PG&E Letter DIL-03-003

Docket No. 72-26  
Diablo Canyon Independent Spent Fuel Storage Installation  
Revised Response to NRC Request for Additional Information 5-1 for the Diablo  
Canyon Independent Spent Fuel Storage Installation Application (TAC No. L23399)

## Revised Response to Request for Additional Information for Diablo Canyon Independent Spent Fuel Storage Installation (ISFSI) License Application

#### Question 5-1

Enclosure 2 contains a draft of SAR Figure 4.2-2.

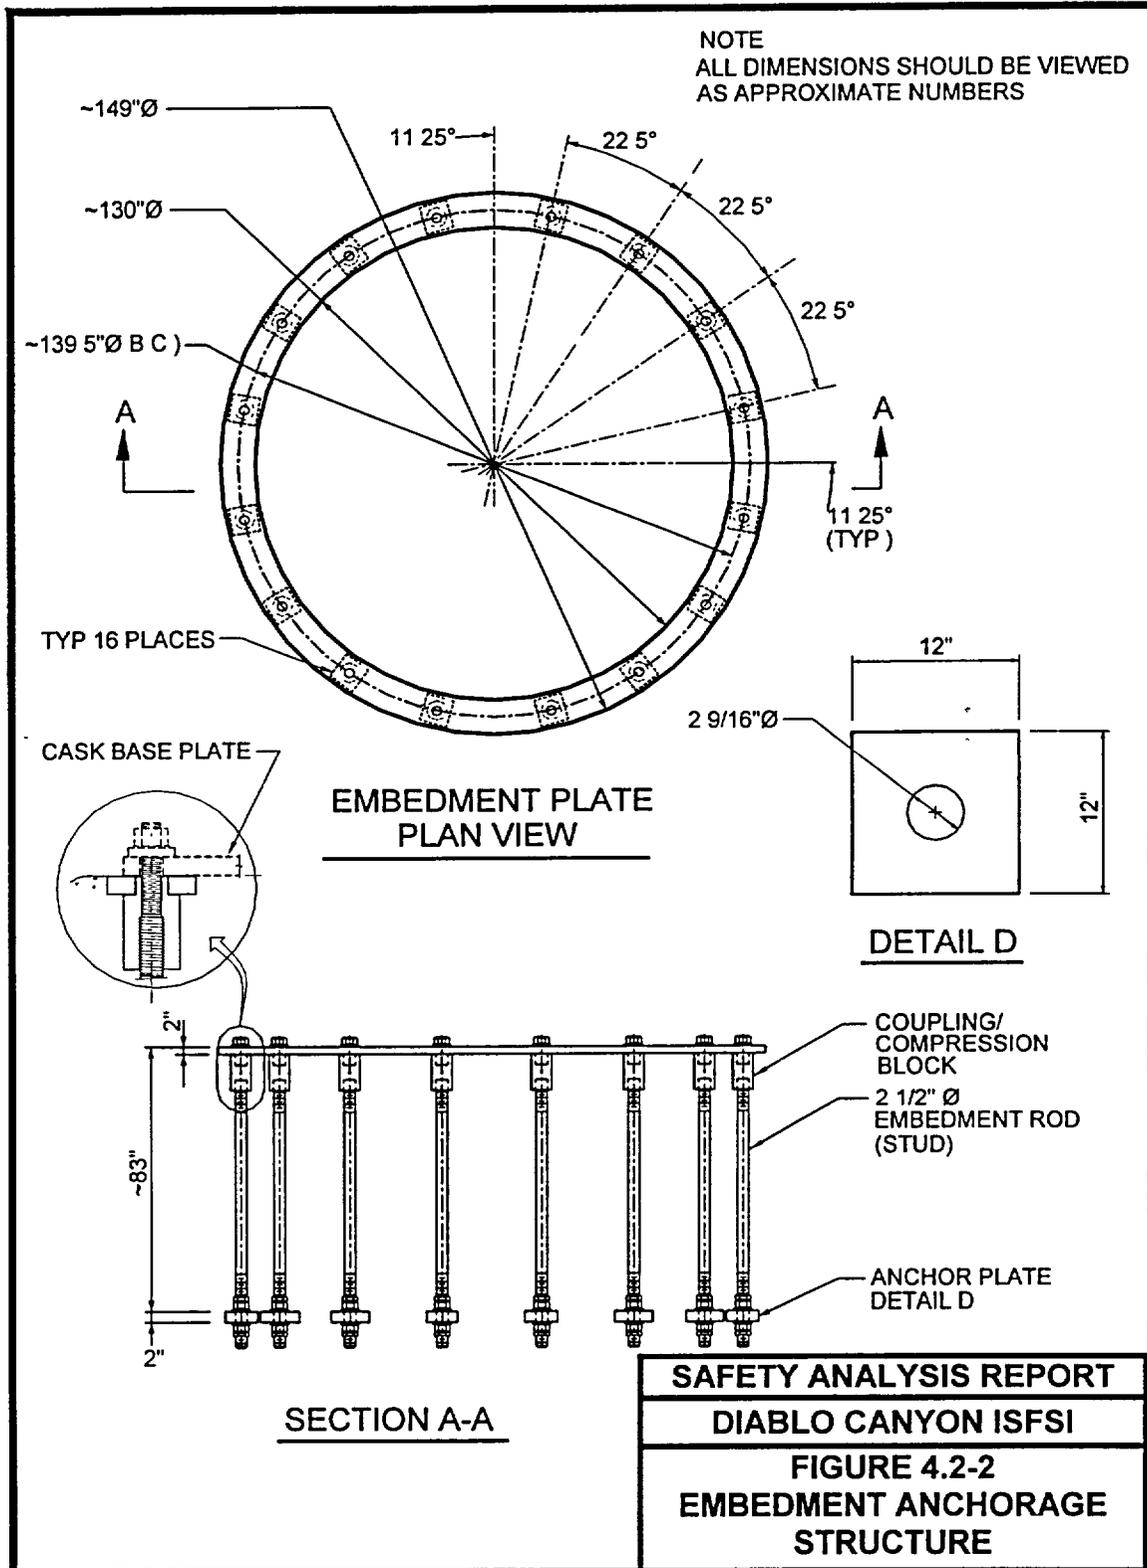
*Provide an evaluation to support the conclusion that the concrete will not break out of the storage pads prior to failure of the ductile metal members.*

*The Diablo Canyon ISFSI Safety Analysis Report (Section 3.3.2.3, ISFSI Concrete Storage Pad: Design Criteria) states that the design strength capacity of the embedded base plate, concrete bearing, and diagonal tension shear capacity are in accordance with the design provisions of American Concrete Institute 349-97 and the embedded anchorage will meet the ductile anchorage provisions of the Proposed Draft New Appendix B to American Concrete Institute 349-97 (dated October 1, 2000). Supporting evidence that the concrete will not break out prior to failure of the ductile metal members is not provided in the Diablo Canyon ISFSI Safety Analysis Report. An evaluation of concrete breakout strength in tension of a group of anchor rods considering spacing and edge distance should be provided.*

The RAI requests supporting evidence that the concrete will not break out prior to failure of ductile metal members allowing for grouping of anchors and edge distance. The tension tie-rods are not treated like anchors for the reasons stated above in the design philosophy. They are treated as inverted columns on base plates and are sized to have lower ultimate strength than the surrounding concrete strength in bearing and diagonal shear as provided by the provisions of the main body of the code. As such, the design ensures ductile behavior, which meets the intent of Appendix B to the ACI 349 code. Attachment 1 provides various capacity calculations for different elements in the load path, thus providing the required evidence as stated above. Furthermore the design has substantial margin between the yield capacity of the weakest element (tension tie-rods) and the imposed tension pull-out demand load.

The load path for delivery of shear load into concrete is through the coupler at the top of the tension tie-rods. As such, the tension tie-rods are not relied on to deliver any shear load into concrete.

Lastly, the combination of the tension (pad flexure) and shear (pull-out) loading in the reinforcing steel and the minimum required steel area has been demonstrated and shown to have considerable margin.
